INDESIT company

Model type:
WP42IT

Commercial code:
F027759

FIG. 1

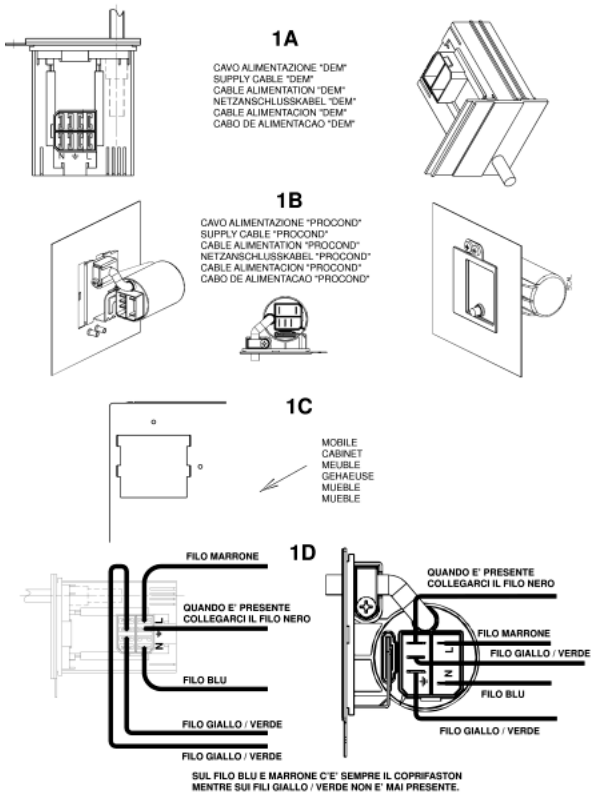
All appliances produced in the Comunanza (from serial no. 21008.0001), Teverola (from serial no. 21111.0001) and Brembate (from serial no. 21119.0001) factories have been equipped with power supply cables with integrally moulded filter (see fig.1 - 1A and 1B) and new units having a specific opening at the back for fixing the new cables (see fig. 1 - 1C).
The new units, together with the new cables, can be used in place of the premodification ones, by connecting the wiring to the cable, as shown in figure 1 - 1D.
The codes of the new units and of those replaced (ESI - table n1040276fig02), which will be managed until stocks run out, are given below.

The premodification wirings, are also managed for modified products by making the connection to the terminal block of the new cable as shown in fig. 1 - 1D.
The wiring diagrams given in the Documentation remain unchanged.

The new power supply cables are:
Code 091632 - Power supply cable 3x1 schuko 1.5m+capacitance filter;
Code 091633 - Power supply cable 3x1 schuko 1.5m+inductive filter;
Code 091634 - Power supply cable UK 3x1 l= 1950mm + inductive filter;
Code 091635 - Power supply cable UK 3x1 l=1950mm+capacitance filter;
Code 091636 - Power supply cable l=2.55m AUS+inductive filter;
Code 091641 - Power supply cable l=2550mm AG +capacitance filter;
Code 091642 - Power supply cable 1.85mt SHUKO no inductive filter;
Code 091643 - Power supply cable 3x1 (CH) 1.5m+inductive filter;
Code 091645 - Power supply cable 3450mm SOUTH AF.+capacitance filter;
Code 091690 - Power supply cable shuko l2.55m KOREA+inductive filter;
Code 091689 - Power Supply cable l=2550mm AG+inductive filter.

IMPORTANT: the fixing / continuity screw is a specific self-scraping screw (code 092348) that ensures earth continuity between the filter and the unit. The same screw must be refitted in order to guarantee machine conformity.

FIG. 1

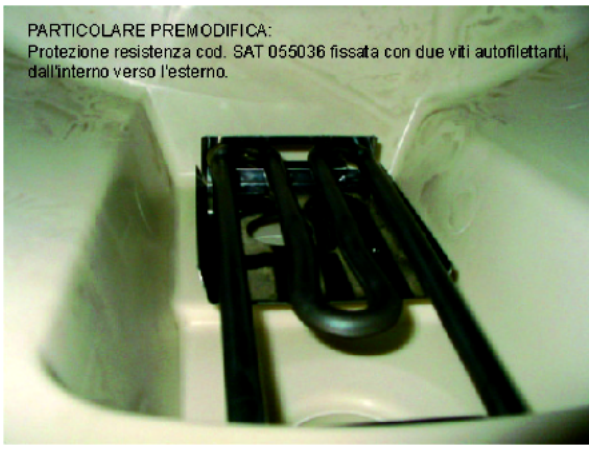
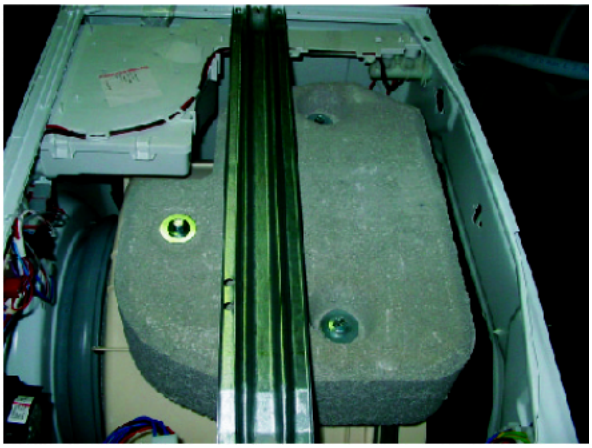
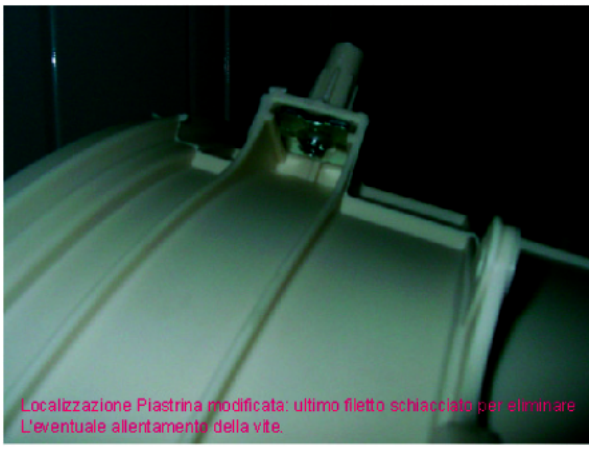
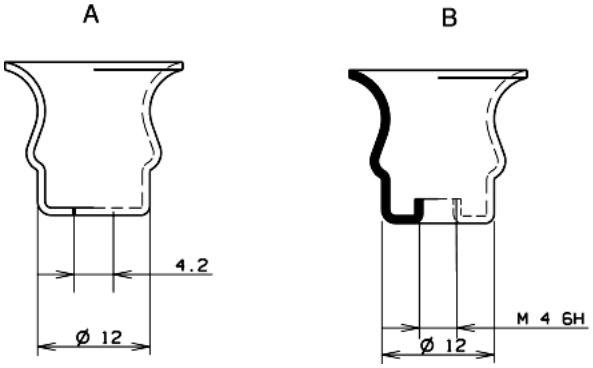
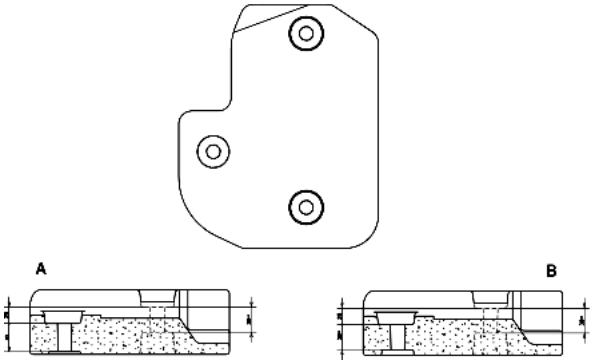
From serial no. 21015.001, a heater retaining element bracket (see fig.3) has replaced the heater retaining element protection Sat code 055036 (see fig.4) on all plastic tanks installed in washing machines produced in the Teverola factory.

The new part (fig. 1A) is fixed to the bowl with a self-tapping screw from the inside outwards and differs from the one used in the Comunanza factory (fig. 1B) in the fixing hole which is not threaded.
In order to reduce the number of parts used, only kit 058523 is managed and which, if used on the Teverola washing machines, must be fixed with a self-tapping screw, instead of metric, after widening the tapped hole with a suitable drill bit.
When inserting the heater retaining element, particular care must be taken so that it is fitted correctly (Fig. 3).
The plastic tanks to be arranged for the guide have the same Sat code as those with the protection.

>From serial no. 21121.0001, the counterweight Fig. 2B with outlet increased by 5 mm in the centre has replaced the previous counterweight Fig. 2A.
The new counterweight (fig. 5) is fixed using three M8 X 63 mm screws with washer code 092016 (see fig. 8) and three plates with the last thread flattened (fig. 6) to prevent accidental loosening of the screw.
All the plates code 055038 in stock in the Centralised Warehouse have been replaced and can also be used on premodification appliances.
The modified counterweight has the same Sat code as the premodification item (066615) that will be managed until stocks run out.
The new counterweight must be assembled using the new screws and plates (see fig. 7).
Both counterweights can be employed necessarily using the following fixing parts which are specific for each type of counterweight:

Fixing parts for premodification counterweight (see fig. 9):
3 pieces code 055019 - Screw M8 X60 mm;
3 pieces code 055018 - Conical washer;
3 pieces code 034336 - Flat washer;

Fixing items for modified counterweight:
3 pieces code 092016 - Screw M8 X 63 mm with washer;
3 pieces code 055038 - Plate with last thread flattened;

FIG. n1040305fig01

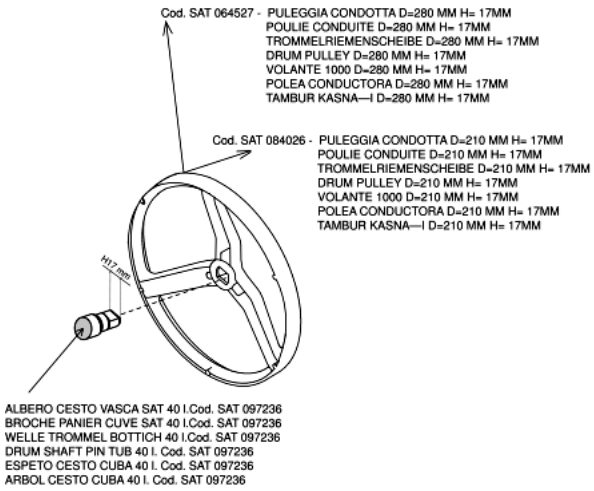
Since August 2003, the following modifications are gradually being made to the oscillating unit on 2000 range models produced in the Teverola factory:
Gradual use of the EVOII 40 litre plastic bowl (code 097236) which differs to the previous LB2000 version, for the following characteristics:
1) Assembled with basket and welded bowl lid;
2) Elimination of detergent recovery tube hole (where provided);
3) Diameter 30 cm opening instead of 28 cm;
The last two numbers of the Industrial Code (given on the rating plate) of the models relevant to this system will be 30 (e.g. 46268790030)
This modification has involved the use of a new table for the oscillating unit (1140240) in the documentation of the relevant models, and for the appliances the following parts have been used:

·Eeproms - The new software for the 40 litre EVO washing machines can also be used on premodification appliances; it is managed with the same Sat codes as the previous software, which is being immediately replaced as the new models enter into production.
·Pulleys - The use of a single 40 litre bowl assembly in Assistance involves management of the pulleys used in production (097268 and 097267) and also those required for creating the various combinations (see fig. n1040305fig.01):

NB: From serial no. 31103.0001, all EVO appliances are equipped with a 40 litre bowl with H=15 mm drum cross shaft which will be managed with the same SAT code (097236) as the 40 litre bowl with H=17 mm shaft until stocks last.
To create the various combinations, the following pulleys are required:

Code 064527 - Pulley D=280mm H=17 mm;
Code 084026 - Pulley D=210mm H=17mm.

Code 097268 - Pulley D=280mm H=15 mm;
Code 097267 - Pulley D=210mm H=15mm.
Exceptions to this are models W93UK (23330) and W103UK (23334) which are equipped with a 46 litre bowl; therefore if the bowl needs replacing code 096198 with 20 mm pulley cross shaft must be used.
In production, pulley code 064527 (diameter D= 280 mm and central hole H= 17mm) is used; therefore, when replacing the bowl, code 097269 (diameter D= 280 mm and central hole H= 20mm) must be used.
